## Product Change Notification - LIAL-25FTVP919

CCB 4000 Final Notice: Implement Packing Changes for selected Microsemi PoE products

**CCB#4000: Implement Packing changes for selected PoE-MCU products**  
**PCN#: LIAL-25FTVP919**

# TRAY: PD81000 PoE-MCU

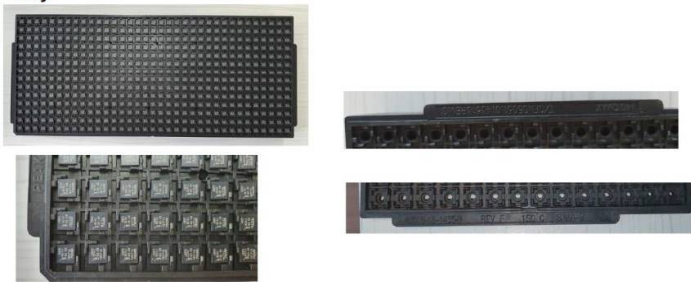
Row	Col	Bakeable (Temp C )	Pocket Pitch (X)	Pocket Pitch (Y)	Outer Pocket center to Tray edge (X)	Outer Pocket center to Tray edge (Y)	Units per Tray
PRE	14	35	140	8.80	9.20	7.90	8.15	490
POST	14	35	150	8.80	9.20	7.90	8.15	490

# Moisture Barrier Bag (MBB) for Tray PoE-MCU

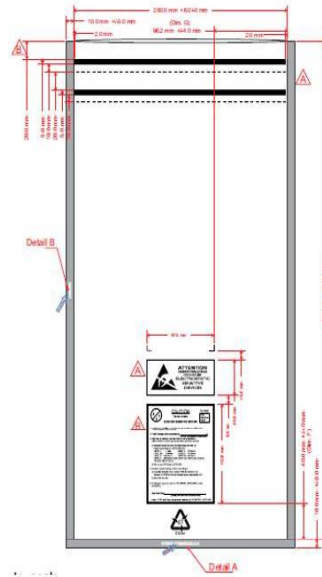
Pre-print: MSL Caution label

# Static Shielding Bag (SSB) for Tray (MSL-1 product) PoE-MCU

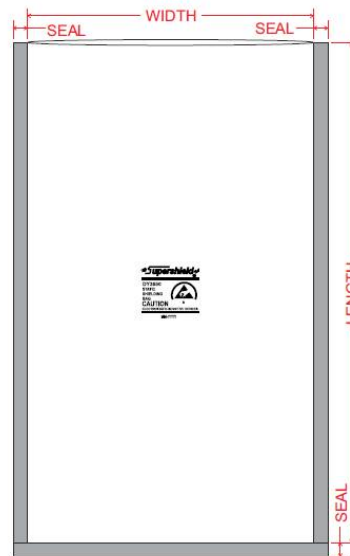
MBB

SSB

# Tray Packing Method PoE-MCU

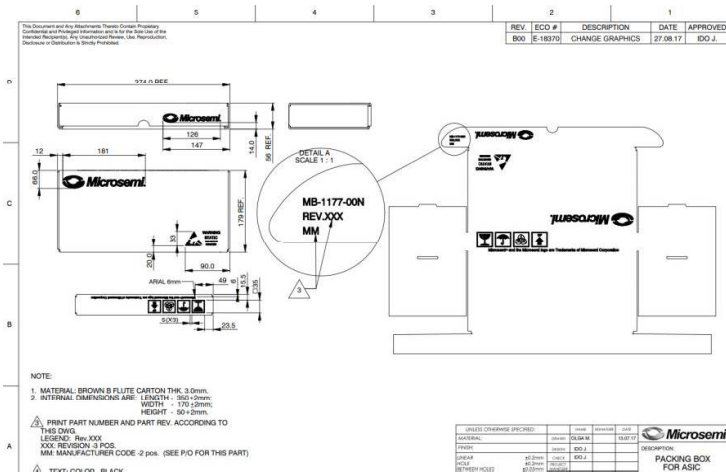
Remove pink foam  
Tray strap: 3+1  
Desiccant: 1unit x 2 bags

# Tray Inner Carton PoE-MCU

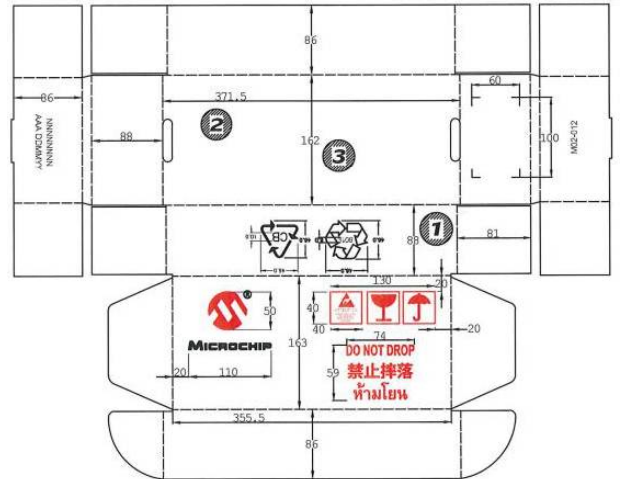
Width	Length	Height
17.9	37.14	5.6

Width	Length	Height
16.2	37.1	8.8

# CARRIER TAPE: PD69200

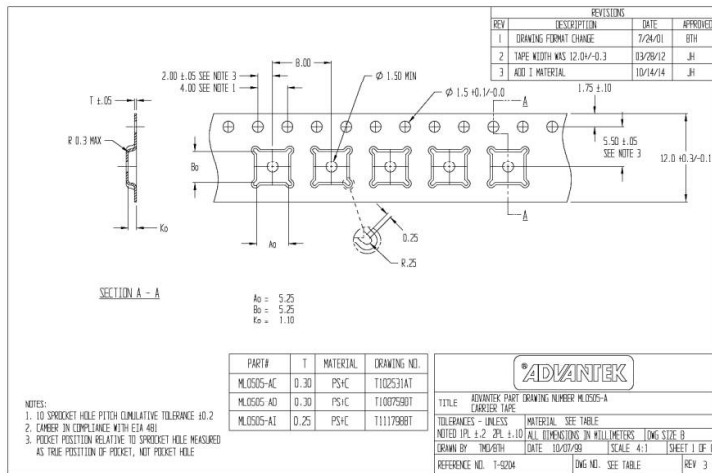
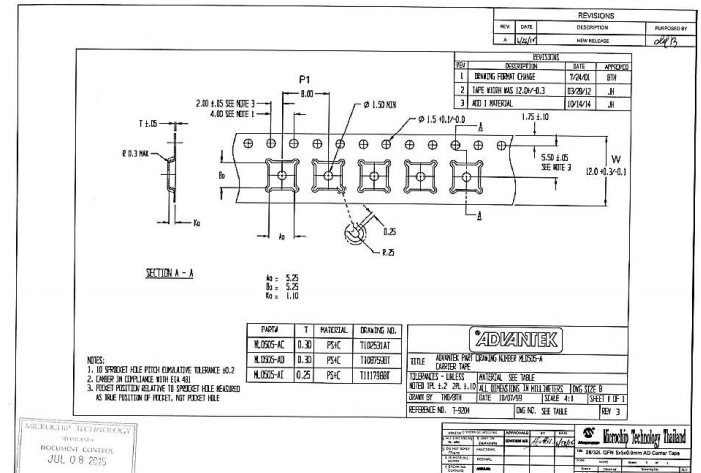
Width(mm)	Pitch(mm)	A0(mm)	B0(mm)	K0(mm)	Thickness(m m)	Units per Reel	Pin1 Orientation
PRE	12	8	5.25	5.25	1.10	0.25 or 0.30	980	Quadrant 1
POST	12	8	5.25	5.25	1.10	0.30	980	Quadrant 1

# REEL: PD69200 QFN 5X5 PoE-MCU

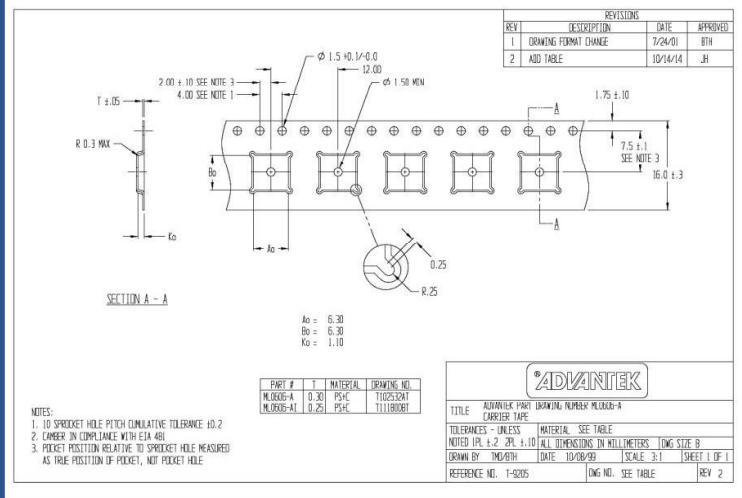
For Carrier Tape Width	Diameter (mm)	Hub (mm)	W1 (mm)	W2 Max (mm)	Color
PRE	12mm	180	60.0	12.4	18.4	White
POST	12mm	178	60.5	12.4	18.4	Dark Blue

# CARRIER TAPE: PD39100 and PD69100 QFN 6x6 PoE-MCU

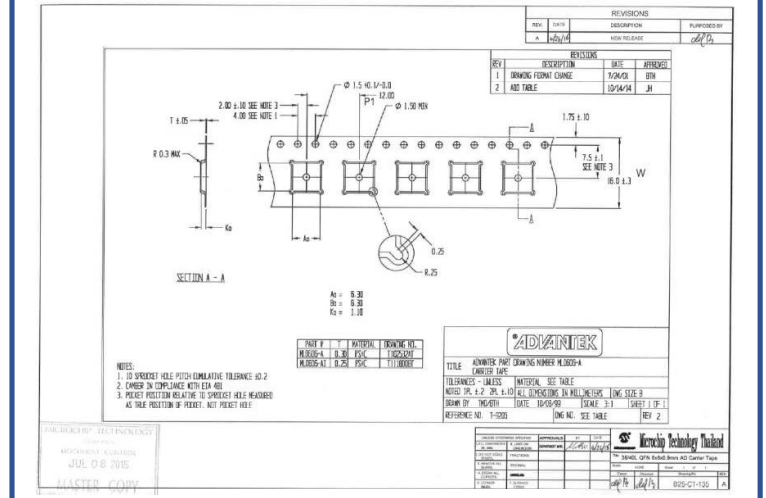
Width(mm)	Pitch(mm)	A0(mm)	B0(mm)	K0(mm)	Thickness(m m)	Units per Reel	Pin1 Orientation
PRE	16	12	6.30	6.30	1.10	0.25 or 0.30	980	Quadrant 1
POST	16	12	6.30	6.30	1.10	0.30	980	Quadrant 1

## REEL: PD39100 and PD69100 QFN 6x6 PoE-MCU

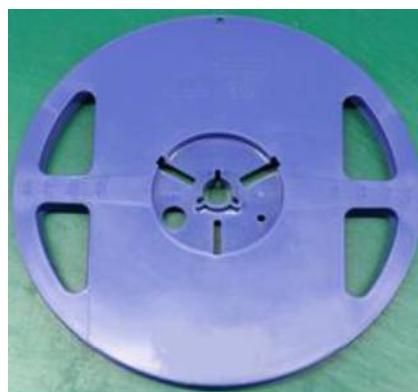
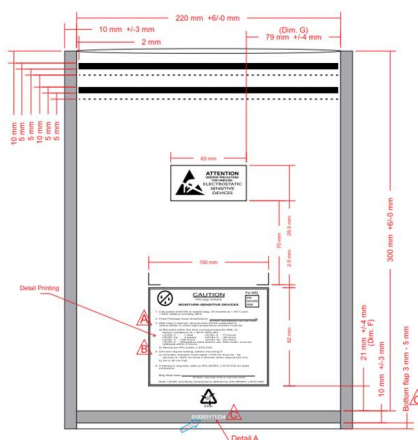
Carrier Tape Width	Diameter (mm)	Hub (mm)	W1 (mm)	W2 Max (mm)	Color
PRE	16mm	180	62.5	16.4	22.4	Black
POST	16mm	178	60.5	16.4	22.4	Dark Blue

# Humidity Indicator Cards (HIC) PoE-MCU

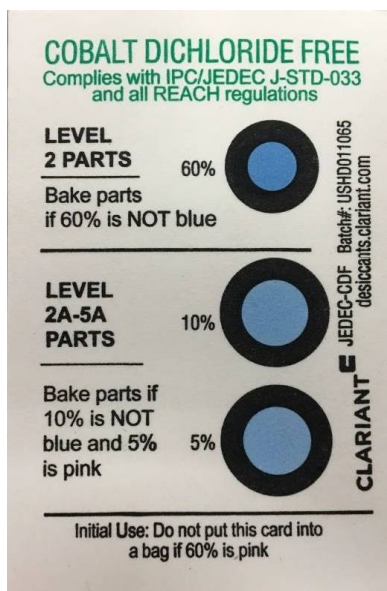
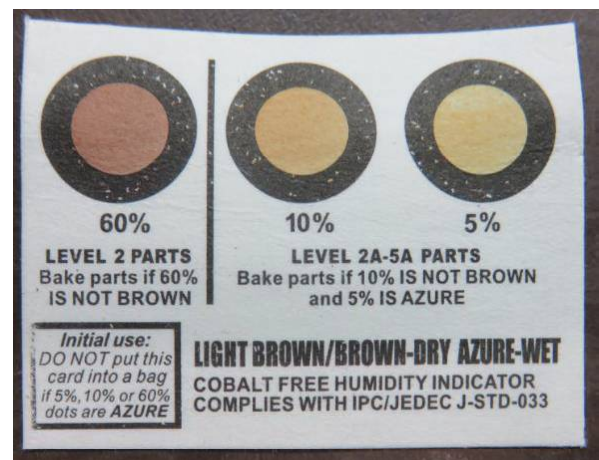
- Cobalt Dichloride free

- Cobalt free only
